URGENT FIELD SAFETY NOTICE

Regarding **ProteusPLUS** and **ProteusONE**

MID-59393 REV. A

Figure 1 - Peak in the center of a beam profile due to dark current. Here the pick value is 110% of the dose but it could be a higher or lower value depending on the intensity of the dark current.

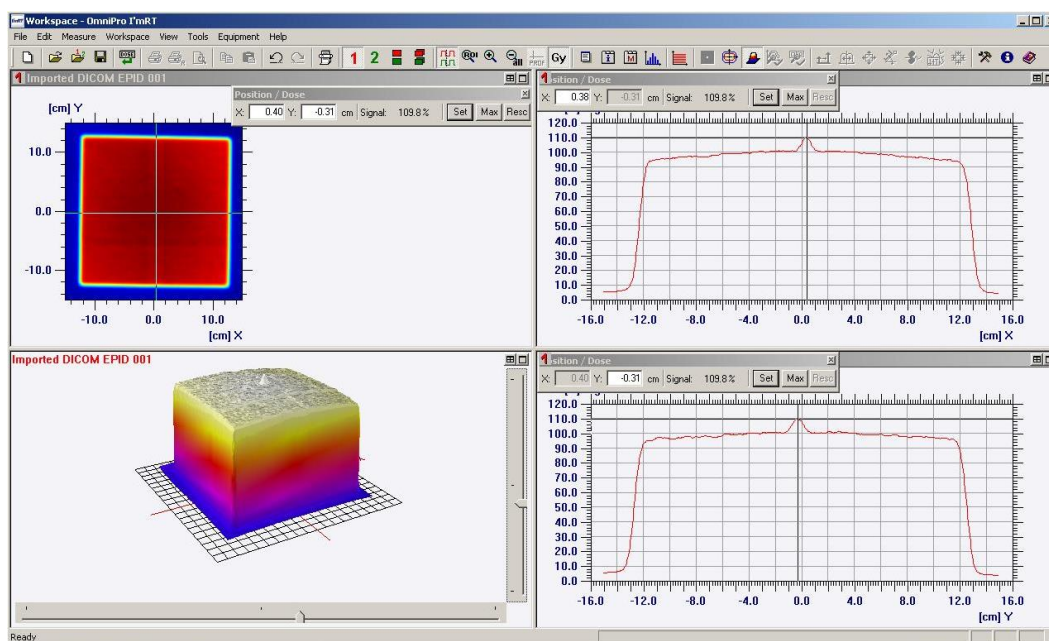
- Run the “Dark Beam” QA Map² with the LYNX dosimetry tool at maximum energy,
- If there is a peak in the center of the beam profile as shown on Figure 1:
 - o Confirm it is due to dark current by running the same QA Map at the lowest energy (if there is no peak, it is most probably due to dark current),
 - o Contact IBA to analyze and fix the issue.

In case a peak is observed on the beam profile, it is suggested to open a downtime event until the dark current issue is fixed.
